**Addendum (Revision 1) to Remedial Action Options Report (RAOR)  
and Pre-Design Sampling Work Plan - Connell Aluminum Properties, LLC  
Former Koppers Tar Plant and Wabash Alloys Site  
9100 S. 5<sup>th</sup> Avenue, Oak Creek, WI 53154  
BRRTS# 02-41-553761, FID#241379050  
Connell VPLE BRRTS #:06-41-560068**

January 11, 2021

**City of Oak Creek Utility Corridor Lot 1  
9170 South 5<sup>th</sup> Avenue, Oak Creek, WI 53154  
BRRTS#: 02-41-561425, FID #:341074470  
VPLE BRRTS#: 06-41-561426**

This Addendum (R1) letter addresses the WDNR's comment letter dated October 25, 2017 and the additional June 10, 2020 comment letter provided to Connell upon WDNR's review of the March 13, 2020 Addendum regarding *Review of Site Investigation and Remedial Action Options Reports, Former Koppers Tar Plant and Wabash Alloys Facility*. On July 7, 2020, Connell participated in a conference call with the WDNR in which we discussed our proposal for revising the Addendum to address the WDNR's June 2020 comments. We discussed increasing the cap extents in several areas to closely match the extents planned by Beazer for capping the creosote-impacted (PAHs) soil, for which WDNR did not have an objec

**FIGURE 3**  
**FIGURE C41 (REV. SI REPORT)**

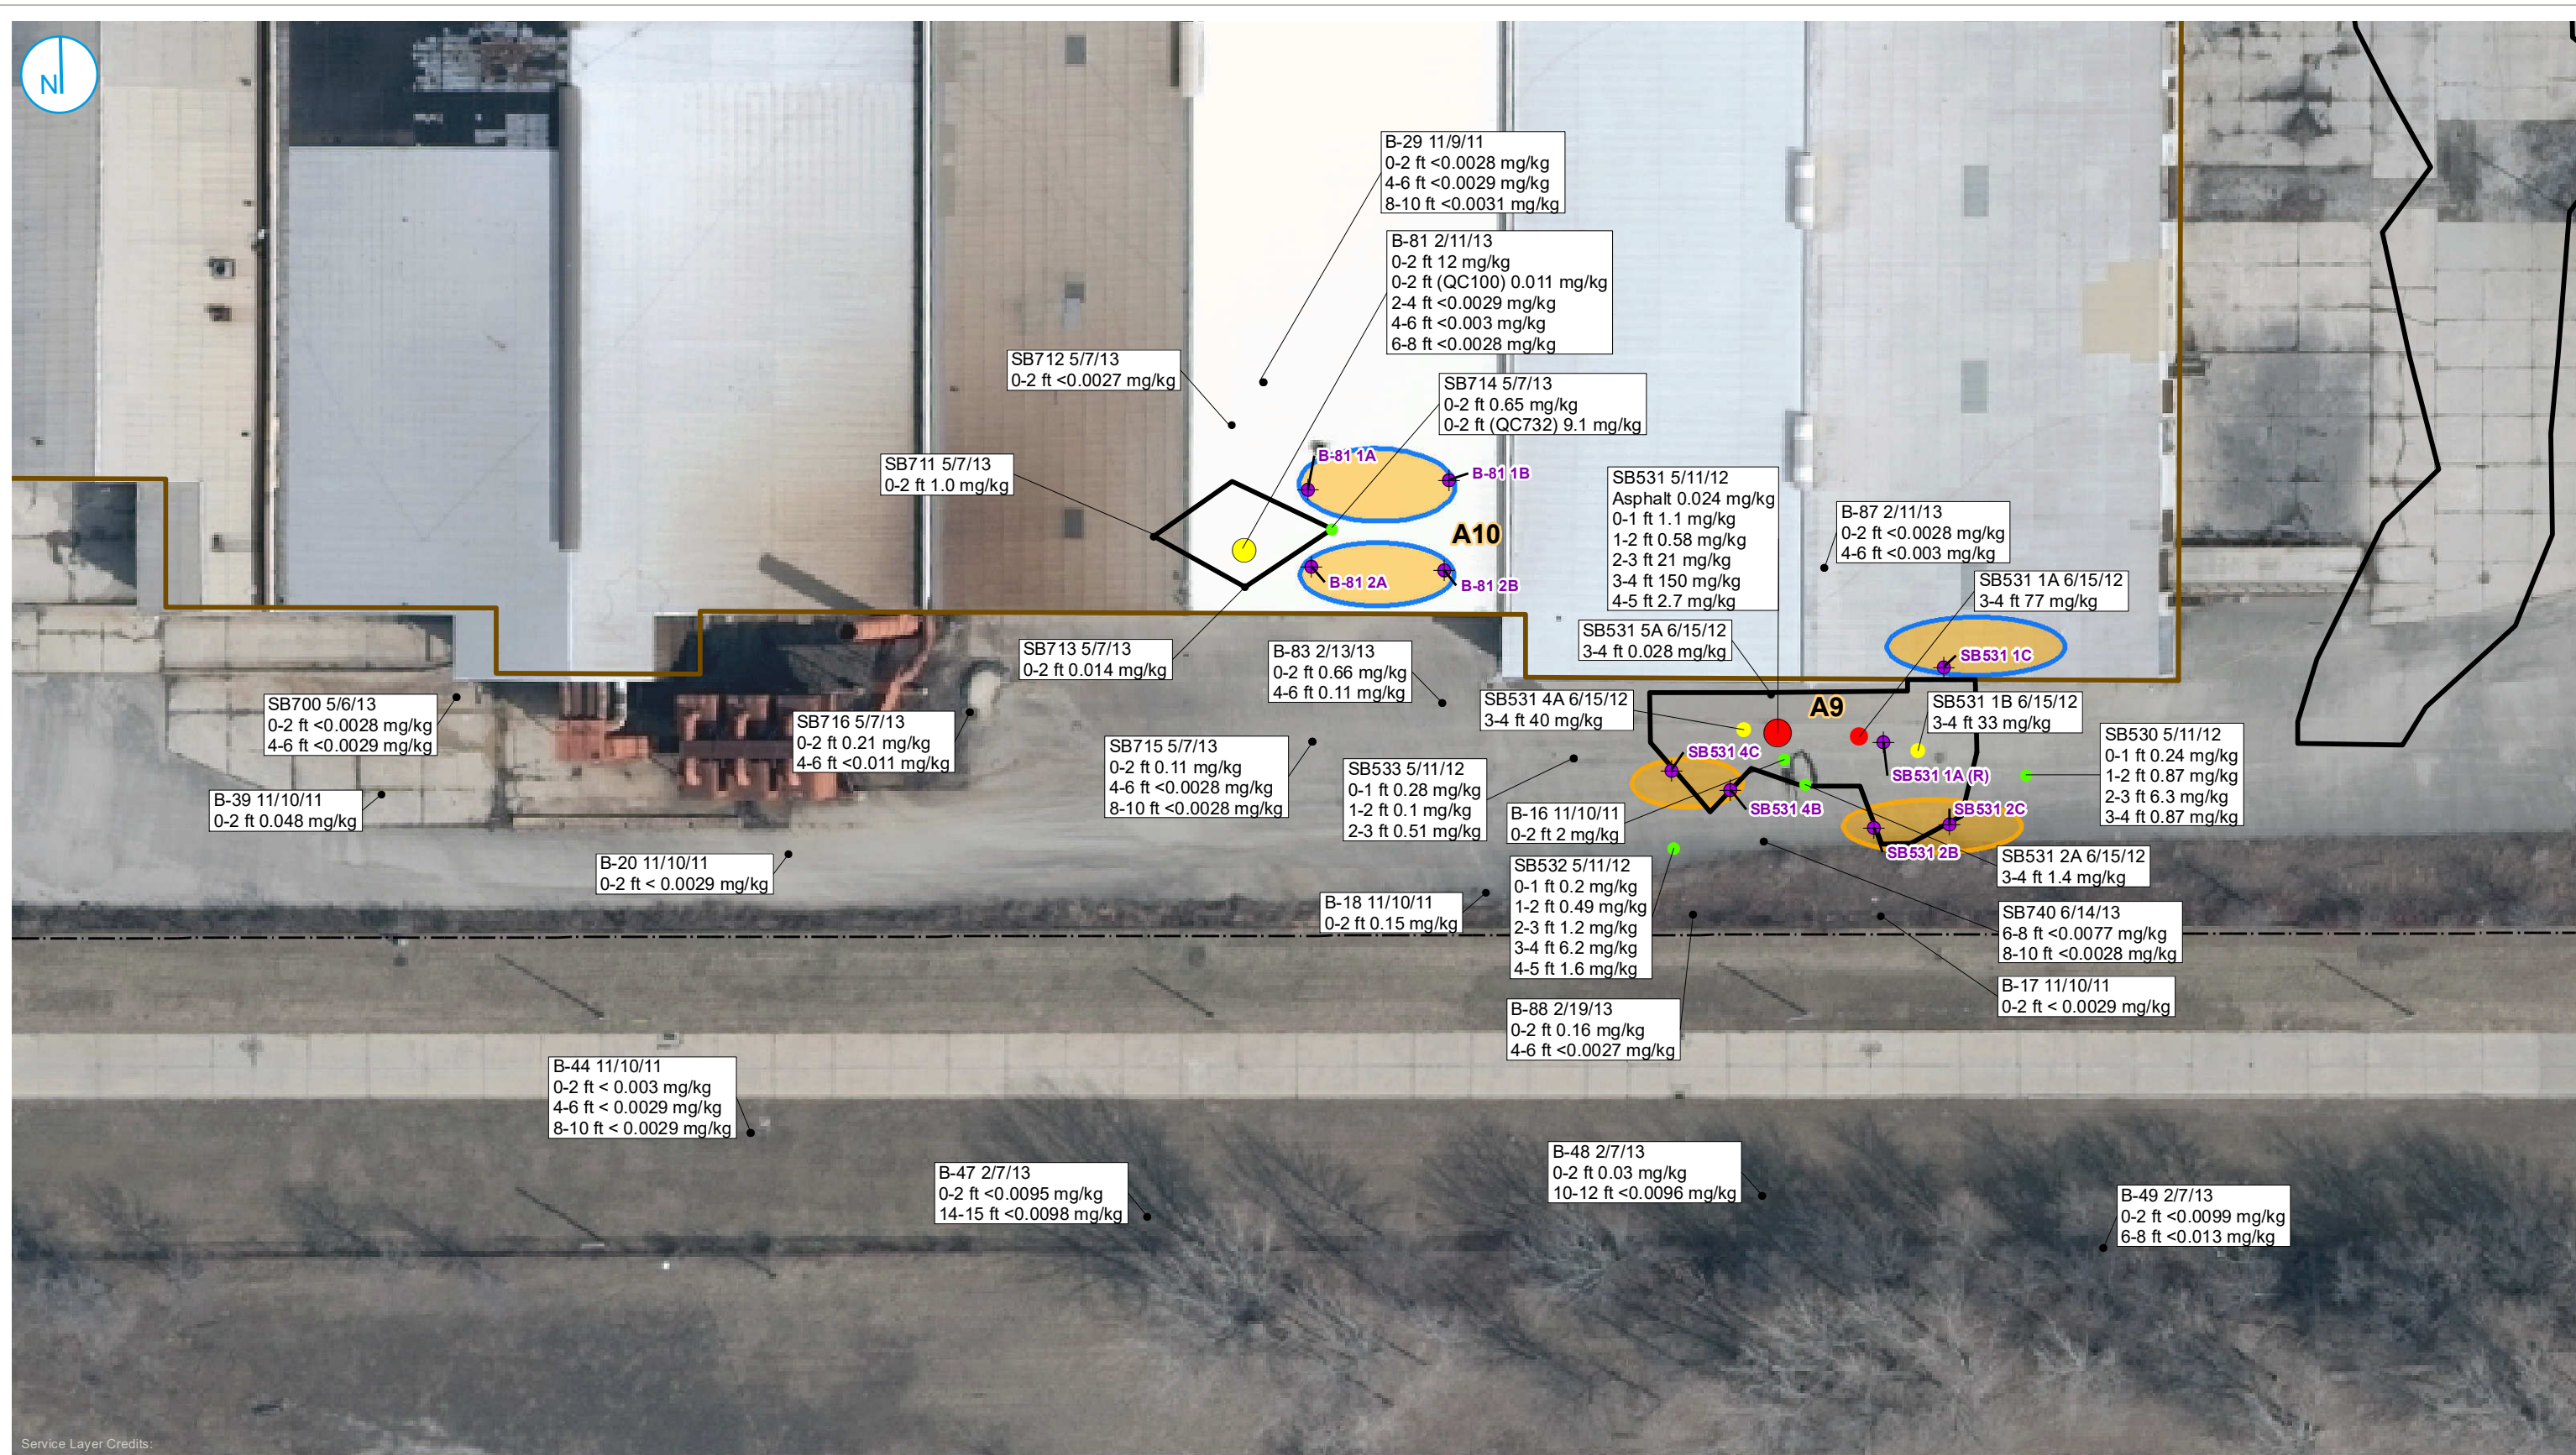
- Figure 3 – Revised Figure C41 SI Report – PCB Soil Data – South Yard TSCA Area for purposes of showing more specifically the additional PCB sampling locations related to comments A6 and A8.

**FIGURE 4  
FIGURE C42 (REV. SI REPORT)**

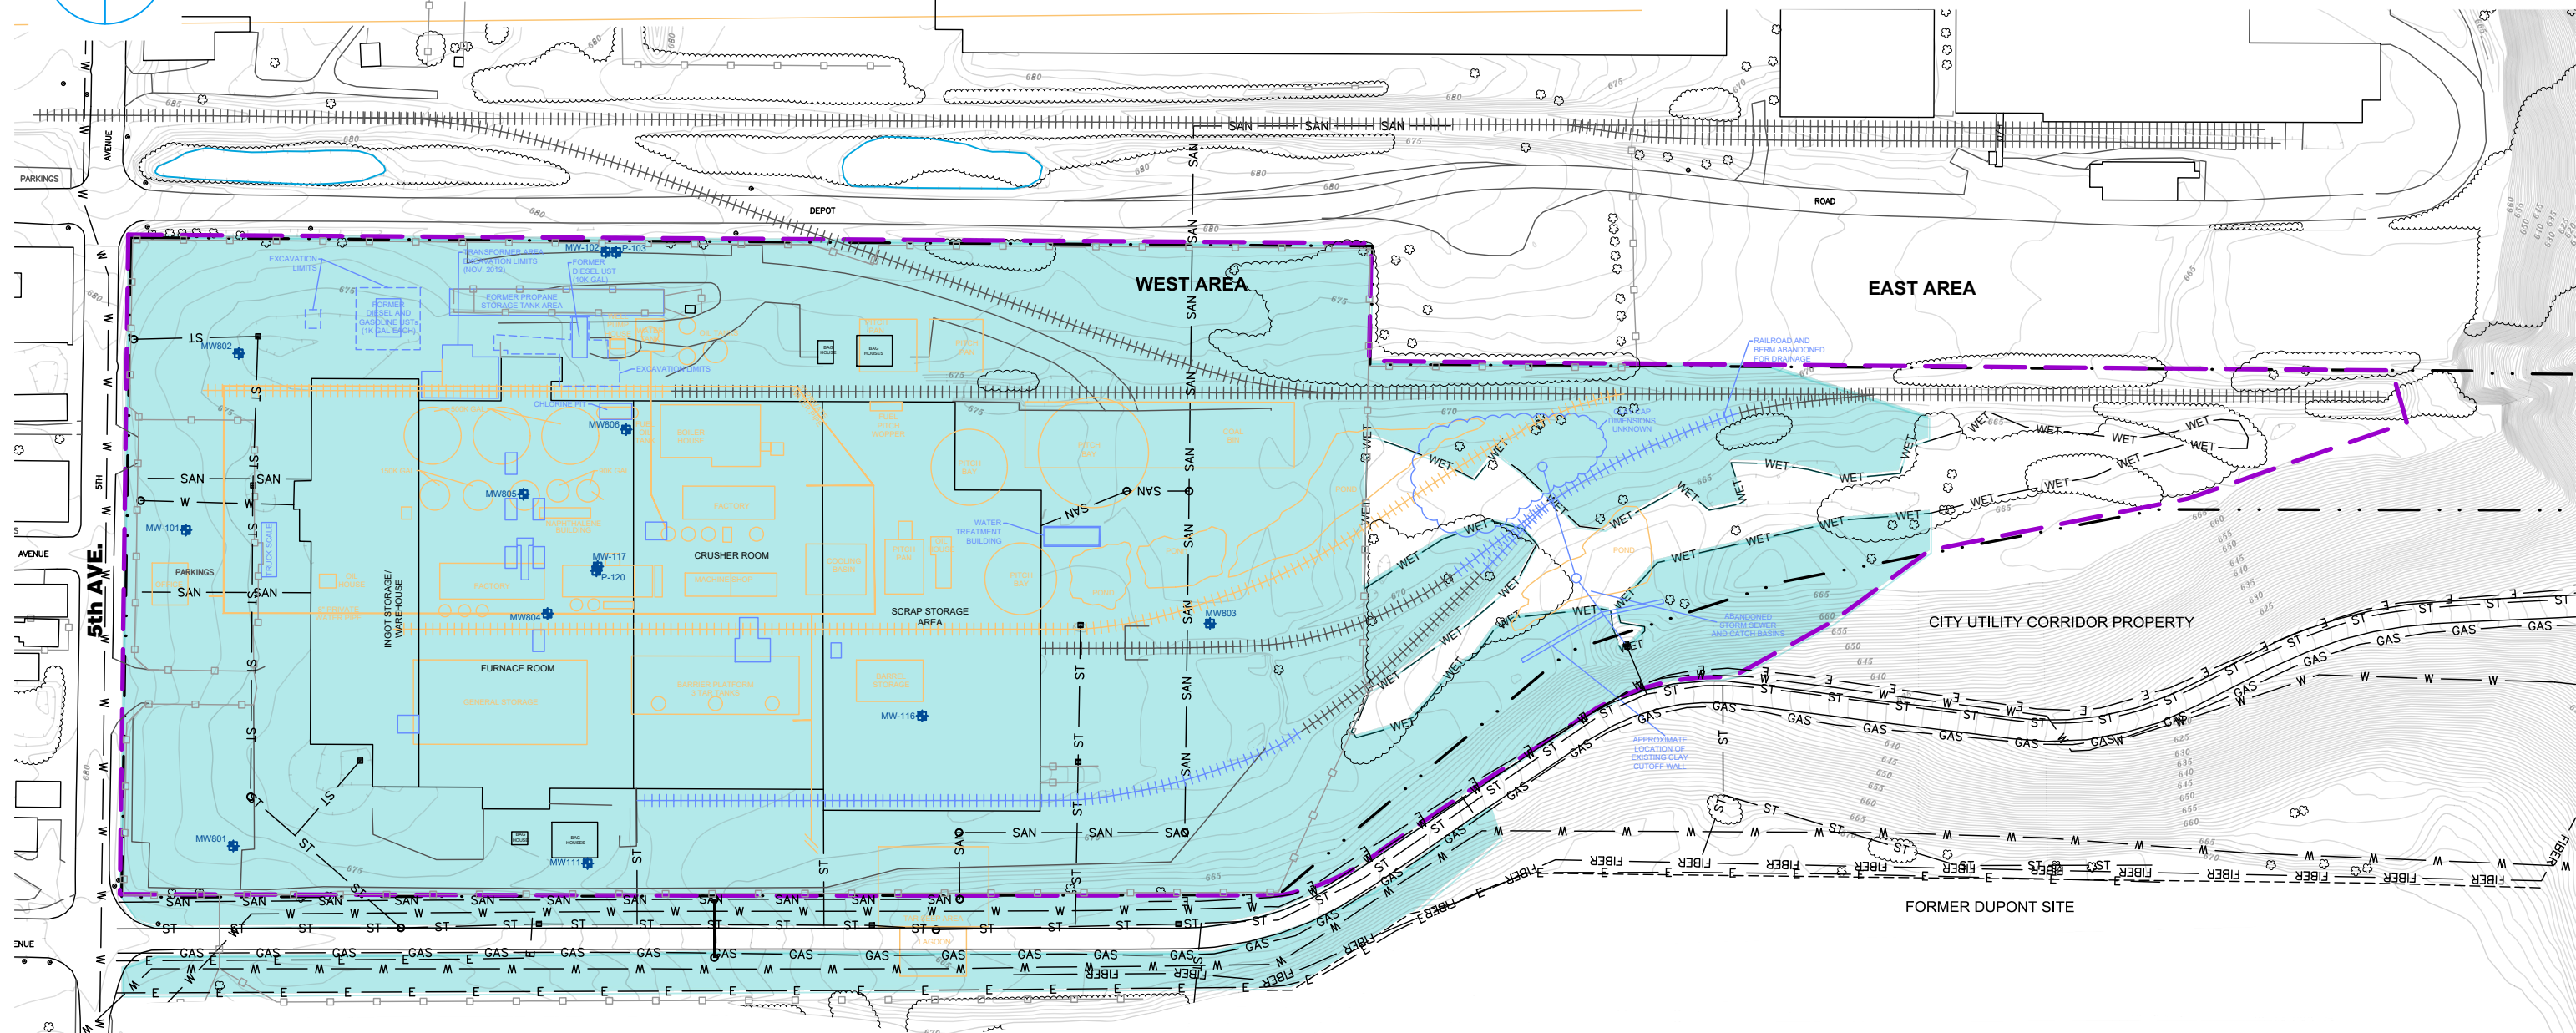
- Figure 4 – Revised Figure C42 SI Report – PCB Soil Data – South Exterior TSCA Area for purposes of showing more specifically the additional PCB sampling locations related to comments A9 and A10.

**FIGURE 5**  
FIGURE 8 (REV. RAOR REPORT)

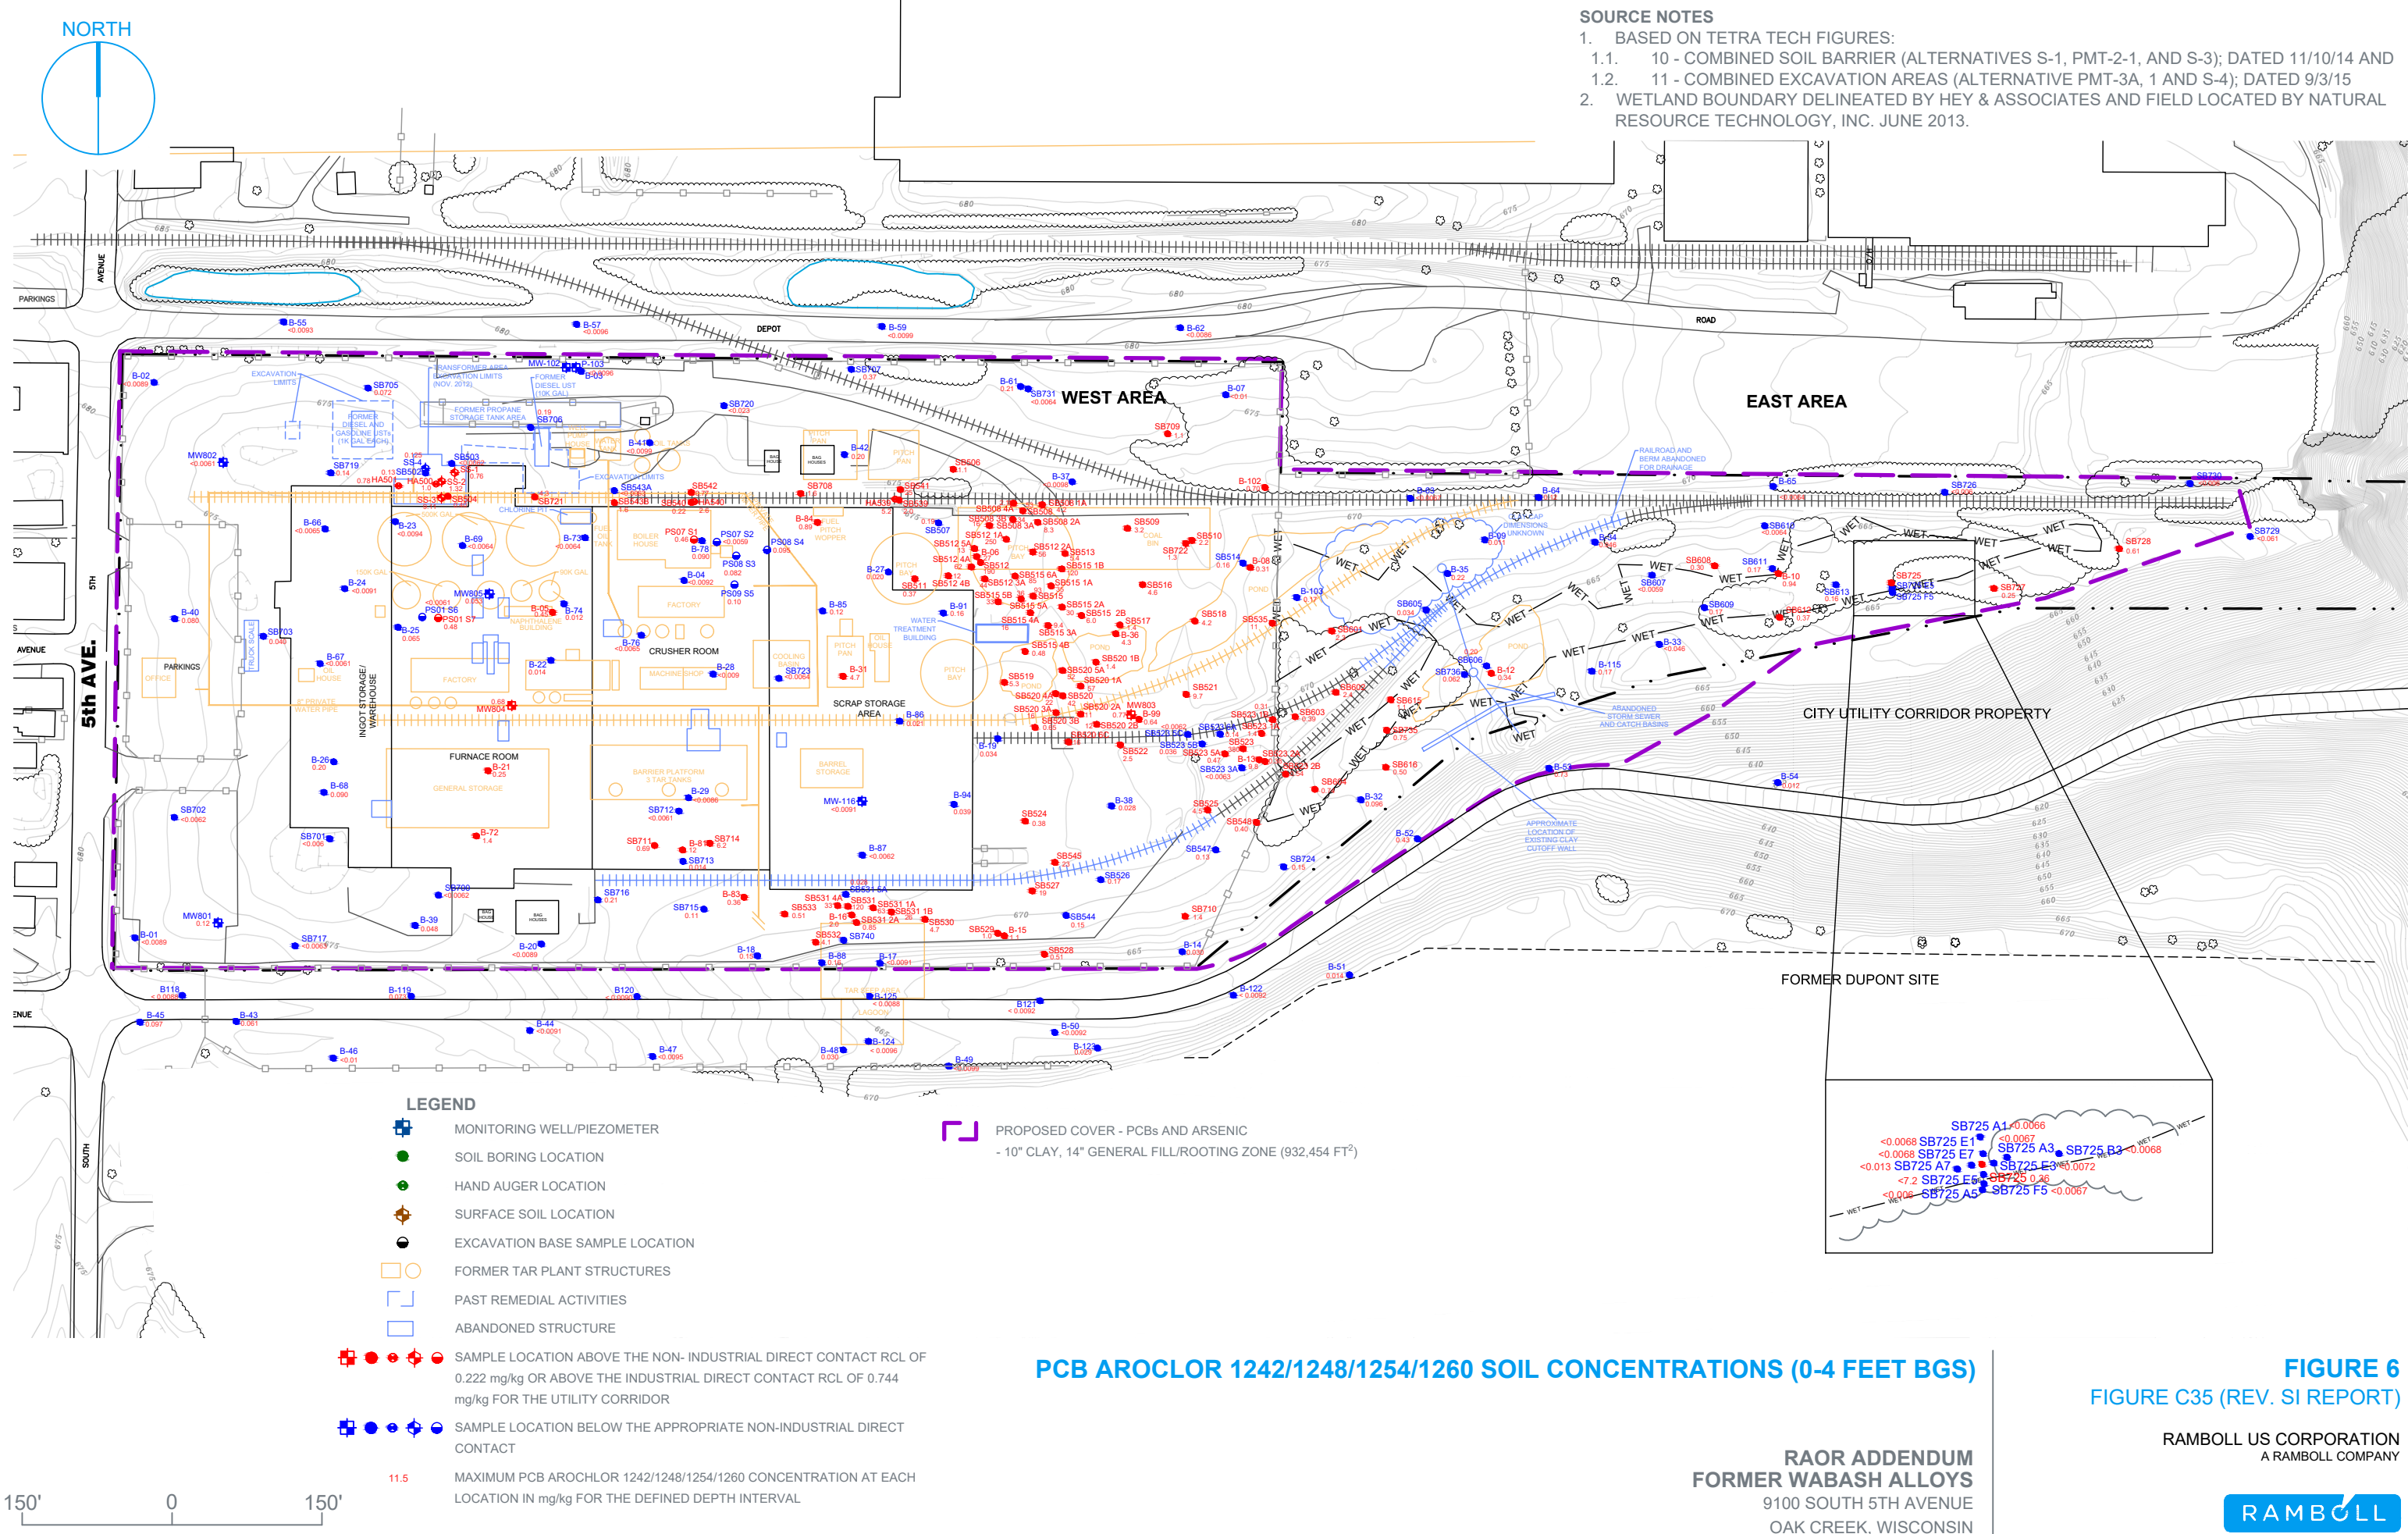
- Figure 5 – Revised RAOR Figure 8 - PCB and Arsenic Soil Barrier (Alternative S-3) for purposes of showing the revised estimated cap extent in both the western and eastern areas.
- Figure 6 – Revised Figure C35 SI Report – PCB Aroclor 1242/1248/1254/1260 Soil Concentrations (0-4 feet bgs) for purposes of showing PCB sampling results and proposed cap extents.
- Figure 7 – Revised Figure C1 SI Report – Arsenic Soil Concentrations (0-4 ft bgs) for purposes of showing arsenic sampling results and proposed cap extents.
